Project Review:**WM2003-06**

Orchard Trail: 43 residential lots

Pond 1 - looking southeast

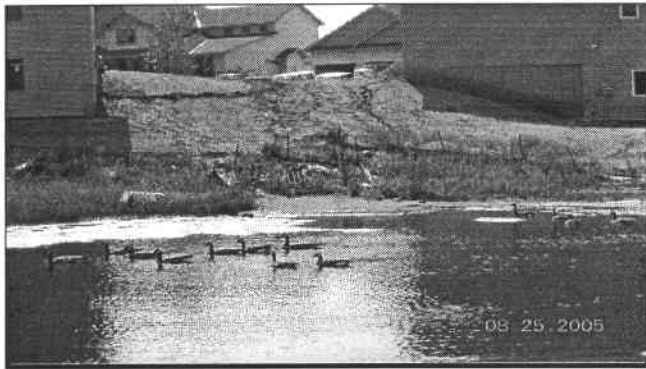
Inlet (s):**Pond 1 (b/t Orchard and Noble, south of 104th)** - erosion at southwest inlet; poor erosion control at perimeter.**Pond 2 (southeast of Orchard & Noble Pond)** - Erosion along west bank**Pond 3 (Southwest of Oxbow Creek and Noble)** - OK, stabilized and not obstructed.**Pond 4 (Southeast of Oxbow Creek and Noble)** - Not visible.**Outlet(s):****Pond 1** - OK, submerged outlet pipe to wetland mitigation to the southeast.**Pond 2** - OK, outlet pipe to east.**Pond 3** - OK, submerged outlet pipe to storm sewer in street.**Pond 4** - It does not appear that outlet structure was built correctly.**Basin(s):****Pond 1** - Vegetated with permanent pool, but erosion on side slopes.**Pond 2** - Vegetated, except for west bank, with permanent pool.**Pond 3** - OK, vegetated with permanent pool.**Pond 4** - OK, vegetated with permanent pool.**Inspection Date:** August 25, 2005**Comments:****Pond 1** - Stabilize erosion at southwest inlet. Install erosion control at pond perimeter.**Pond 2** - Stabilize erosion along west bank of pond.**Pond 3** - No recommended improvements.**Pond 4** - Locate inlets. Confirm that pond outlet structure was constructed as designed.
